Manuscript ID: IJE-2011-3632

Manuscript Title: **Simple slope stabilization on quartz sandstone using horizontal drain**

Response by Authors to Reviewer's Remarks/Comments

Simple Slope Stabilization on Quartz Sandstone using Horizontal Drain

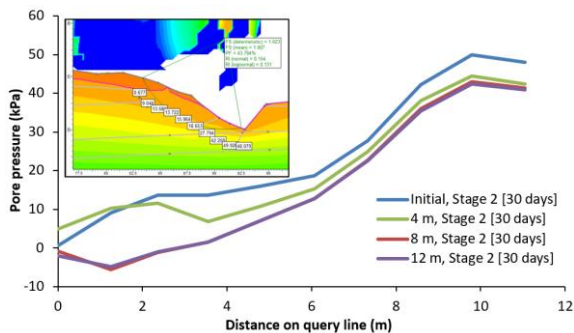
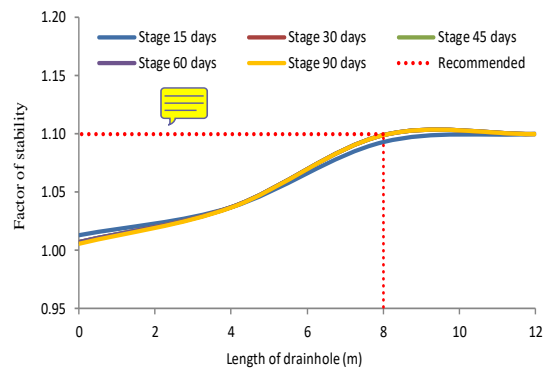
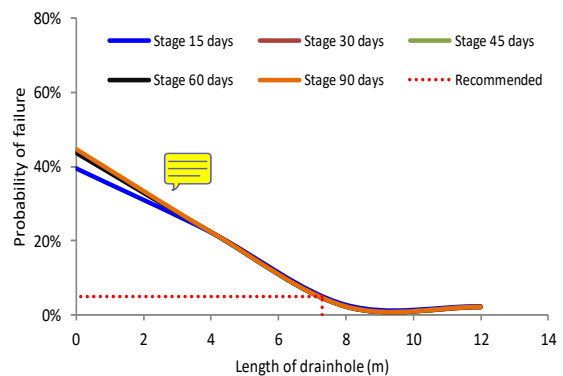
| No | <i>Editor's Comments</i> | <i>Authors Response</i> |
|---------------------|---|---|
| 3 | Improve quality of figures like Figs. 4 to 9. | All figure has been improved and quality as better than previous version. |
